Special Meeting Agenda

- 4.1 Subject:** Development Permit – Operational Works
Earthworks associated with the construction of an irrigation supply channel system
Etta Plains Holdings Pty Ltd
- Attachments:** 4.1.1 – Development Application (*Infoxpert ID: 114083*)
4.1.2 – RFI and further advice notice response (*Infoxpert ID: 114084*)
4.1.3 – Referral agency response – with conditions (SARA) issued 10 November 2020
(*Infoxpert ID: 114085*)
4.1.4 – Draft Decision Notice (*Infoxpert ID: 114086*)
- Author:** Environmental & Regulatory Services Team Leader
- Date:** 26th November 2020
-

To: State Assessment and Referral Agency	From: Sarah Beitel	Attention: Catherine Hobbs
Email: Catherine.Hobbs@dsmip.qld.gov.au		
Project No: BE190153.01	Date: 19 October 2020	
Subject: Request for Information Response – Etta Plains Irrigation Project

Etta Plains Stage 1 Irrigation Project
 Figure 1
 Relevant Purpose Determination Map

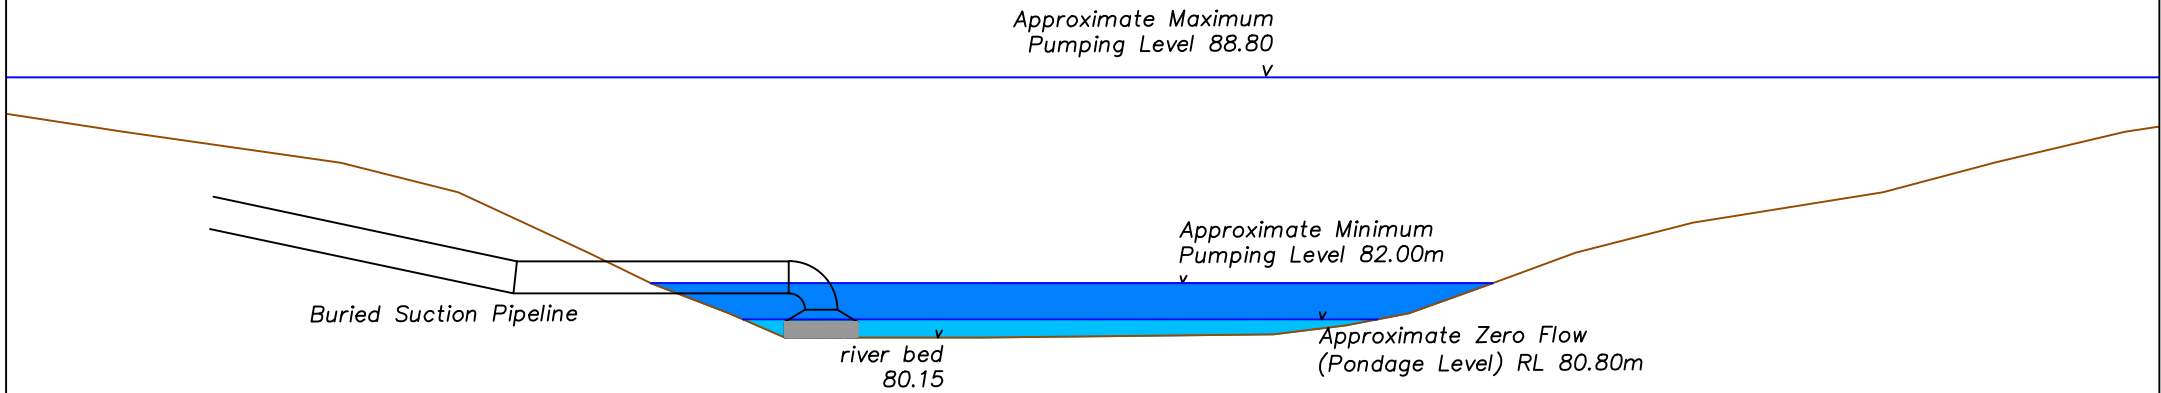
Item	State Issue	Recommended Actions	Response
1	<p>The application states that clearing for the proposed development meets AO11.2 because it does not exceed the relevant widths in table 16.3.1 of the code (being 20m for a sparse regional ecosystem) and only occurs within 10m of the defining bank where clearing is required into Flinders River.</p> <p>This clearing area is identified in digital data provided with the relevant purpose determination application (received 22 July 2020) and by coordinates on the plan provided with the development application titled 'Etta Plains Stage 1 – Irrigation Project – Figure 5: Area to be cleared for a relevant purpose, DRW. No. BE190110.01, Revision/Date 1 August 2020'.</p> <p>An analysis of the coordinates and digital data shows that the clearing for the proposed infrastructure will be 30m wide. As a result, there is insufficient information to demonstrate that AO11.2 is met.</p>	<p>The applicant is required to clarify whether clearing for the proposed infrastructure on Flinders River will be 20m or 30m wide. To meet PO11, the following information is also required:</p> <ul style="list-style-type: none"> if the clearing will be 20m wide, please provide amended digital data for the proposed development in an ESRI compatible format (shapefile, KML or geodatabase) with a projected spatial reference; or if the clearing will be 30m wide, please provide information to demonstrate how clearing for the proposed development will meet a relevant Acceptable Outcome, or the Performance Outcome (PO11). 	<p>The clearing will be 20 metres (m) wide. Amended spatial data showing this has been attached to this email, and a map has been provided in Appendix A.</p>

Findley Farms Pty Ltd
 Etta Plains
 Stage 1- X-Section of Flinders River
 with Location of Pump Suction
 Pipeline and Pumping Levels

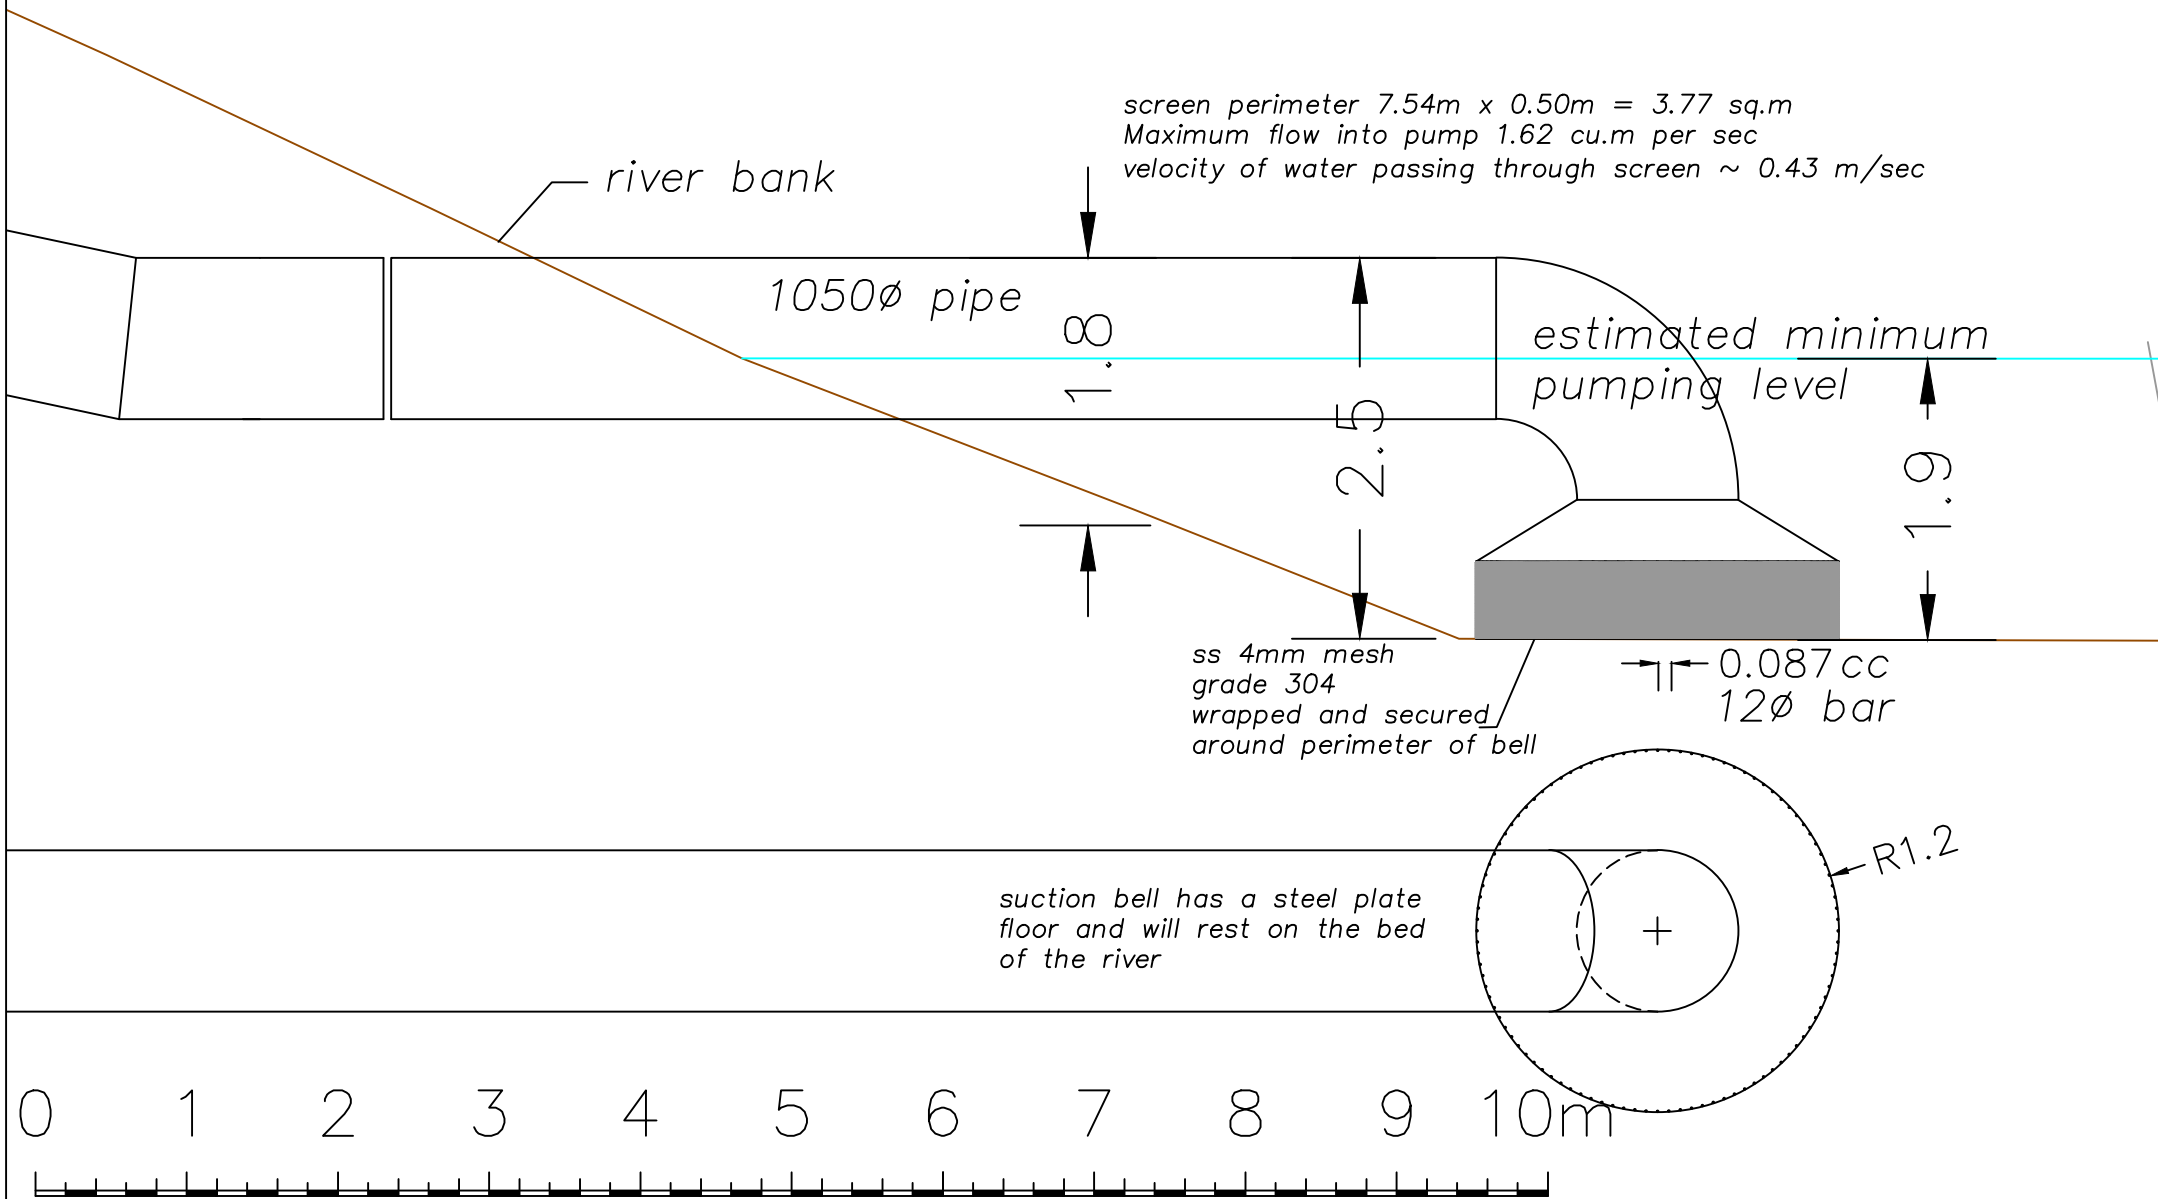
To enable the proposal to be assessed against PO8, provide plans that show fish diversion screens are fixed to all pump intakes.

Discuss screen design in terms of protecting the extant fish community, by considering their swimming speeds, size classes and the potential for entrapment.

Provide screen specifications including screen dimensions, intake velocities, mesh sizes and demonstrate these are adequate to prevent the entrainment of fish in intake flows (see Further Advice Letter dated 24/09/2020).

Please refer **Appendix B** and **Appendix C** for plans of fish diversion screens fixed to the pump intakes.

Fish in the screening in the Flinders River will have two levels of apertures to ensure fish grading. The first will be 74mm and the second will be 4mm, ensuring that both juvenile and adult fish do not get entrapped. All internal farm pumps will also be screened with a 4mm mesh as indicated in **Appendix B**.

Findley Farms Pty Ltd
Eta Plains
Stage 1 development
Flinders River Pumpstation
suction bell details

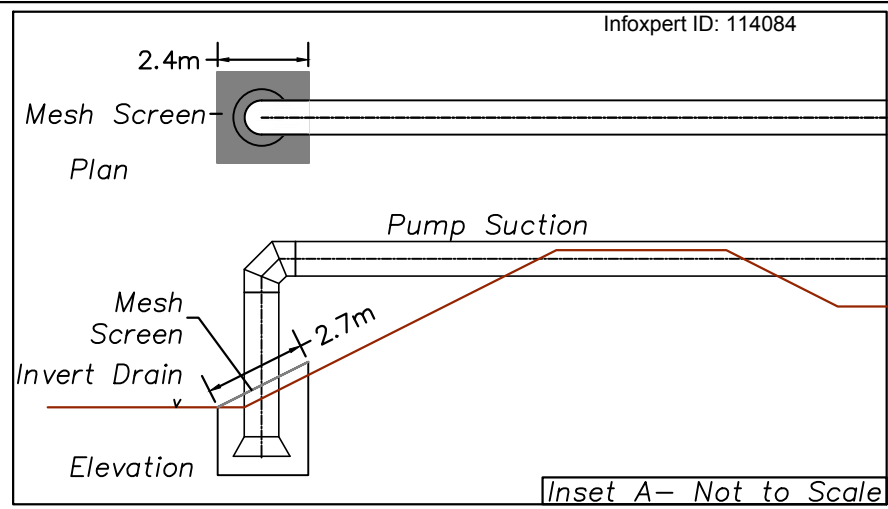
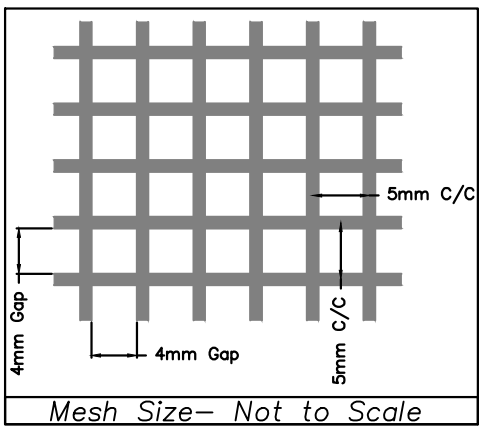
It is necessary to consider two factors to prevent the entrapment of fish at pump intakes:

As previously discussed, whilst information exists on the likely fish species present in the Flinders River, few sightings as far upstream as the location of the pump intake structures have been recorded. The intake velocities are likely to be similar to flow rates experienced at the commencement of the wet season. As indicated, the first mesh lining is 4mm indicating that it will exclude even juvenile fish.
